FORM APPROVED  
OMB NO. 1004-0137  
Expires: January 31, 2018**SUNDRY NOTICES AND REPORTS ON WELLS**  
**Do not use this form for proposals to drill or to re-enter an abandoned well. Use form 3160-3 (APD) for such proposals.**5. Lease Serial No.  
NMLC068281B

BUCK 17 FEDERAL 6H

30-025-40901-00-S1

**Permanent Abandonment of Federal Wells  
Conditions of Approval**

WELLBORE SKETCH  
ConocoPhillips Company -- Permian Basin Business Unit

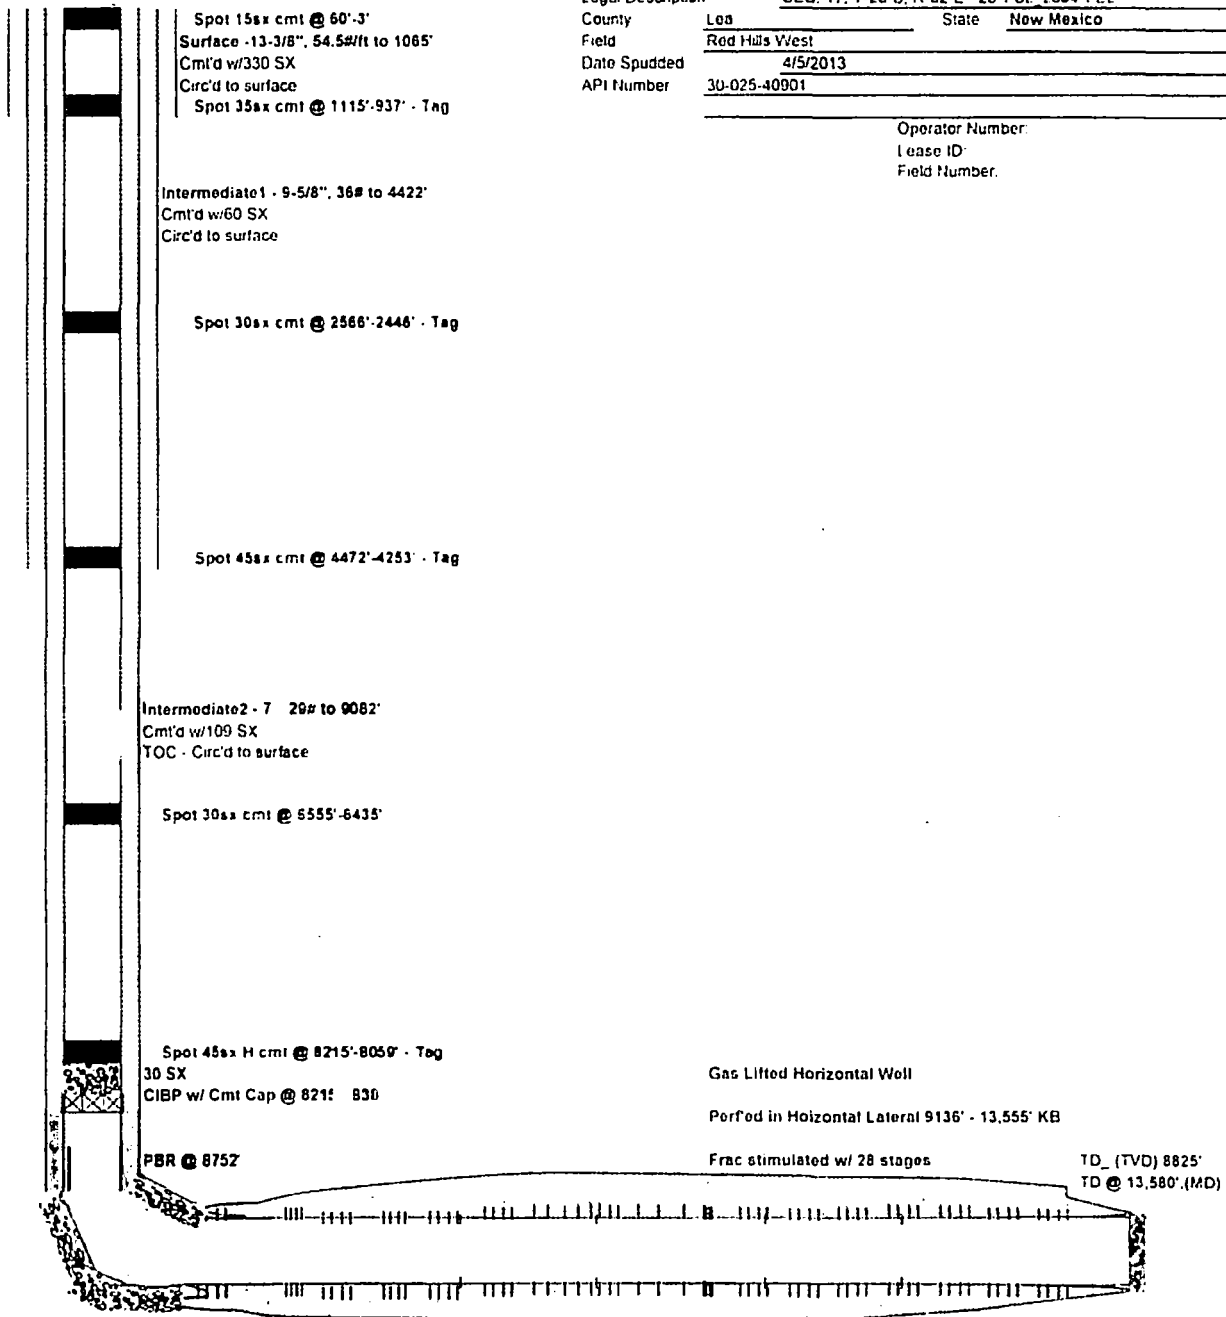
\*\* BLM REVISED \*\* BLM REVISED \*\* BLM REVISED \*\* BLM REVISED \*\* BLM REVISED \*\*
